GENERAL

GAME MANUAL

Figure 3-2: Examples of G18 compliance and non-compliance.

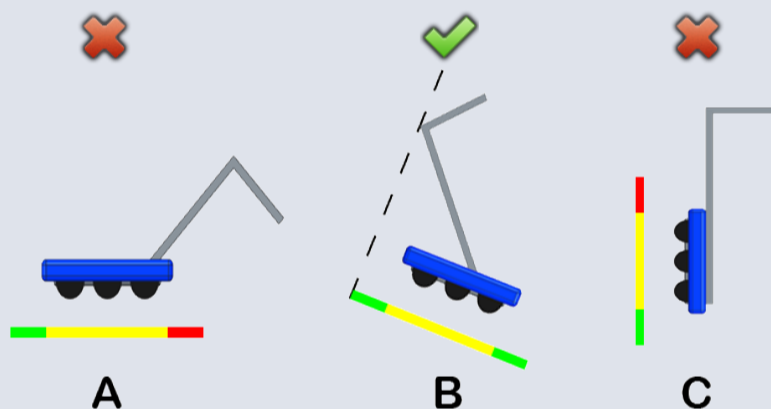
Examples of compliance and non-compliance of G18 are shown in Figure 3-2.

Yellow bars represent the measurement of the FRAME PERIMETER and are drawn in the same orientation of the ROBOT'S FRAME PERIMETER. Green bars represent a measured extension from the FRAME PERIMETER that has not been exceeded. Red bars represent a measured extension from the FRAME PERIMETER that has been exceeded (violating G18). ROBOTS A and C violate G18, whereas ROBOT B does not.

- **G18** ROBOTS may not extend more than 15 in. beyond their FRAME PERIMETER.
